Well Name: FORTY NINER RIDGE UNIT	Well Location: 32.2833941 / - 103.8628572	County or Parish/State: EDDY / NM
Well Number: 118H	Type of Well: CONVENTIONAL GAS WELL	Allottee or Tribe Name:
Lease Number: NMNM0531277, NMNM0531731	Unit or CA Name: FORTY NINER RIDGE UNIT	Unit or CA Number: NMNM70951X
US Well Number: 3001547905	Well Status: Approved Application for Permit to Drill	Operator: MEWBOURNE OIL COMPANY

Notice of Intent

Procedure Description: Mewbourne Oil company request approval to make the following changes to the approved APD: Change BHL from 330' FNL & 440' FEL Sec 15, T23S, R30E to 20' FNL & 1000' FEL Sec 15, T23S, R30E Change casing and cement design as detailed in the attachment Change pool from Purple Sage; Wolfcamp (GAS) (98220) to Forty Niner Ridge; Bonespring (24720) Please contact Mike Loy with any questions.

WELL LOCATION AND ACREAGE DEDICATION PLAT

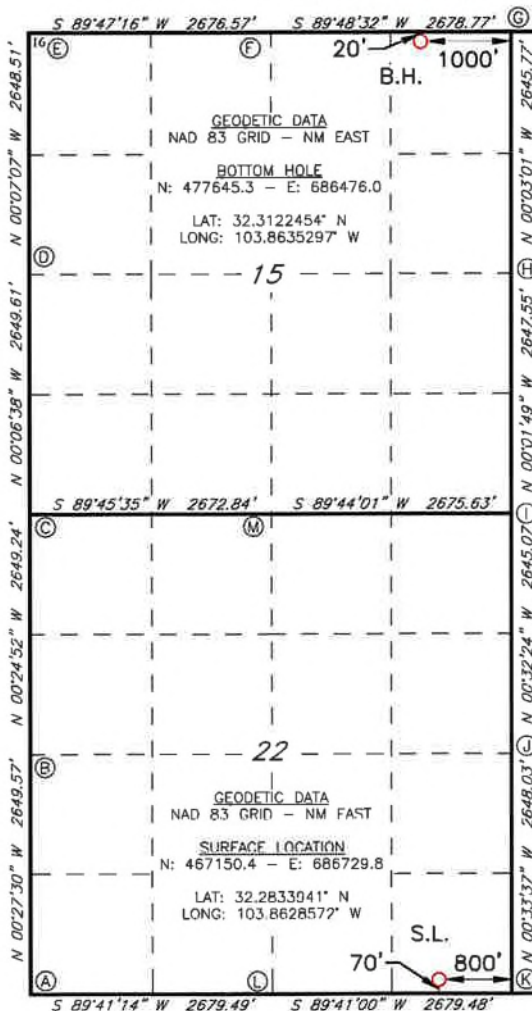
REV: BH MOVE - 6/4/2021

Created By	Condition	Condition Date
kpickford	Adhere to previous NMOCD Conditions of Approval	6/30/2021
kpickford	If this change in plans results in the first or last take points being within 100' of the spacing unit boundary, then an administrative order for non-standard location will be required prior to placing the well on production	6/30/2021
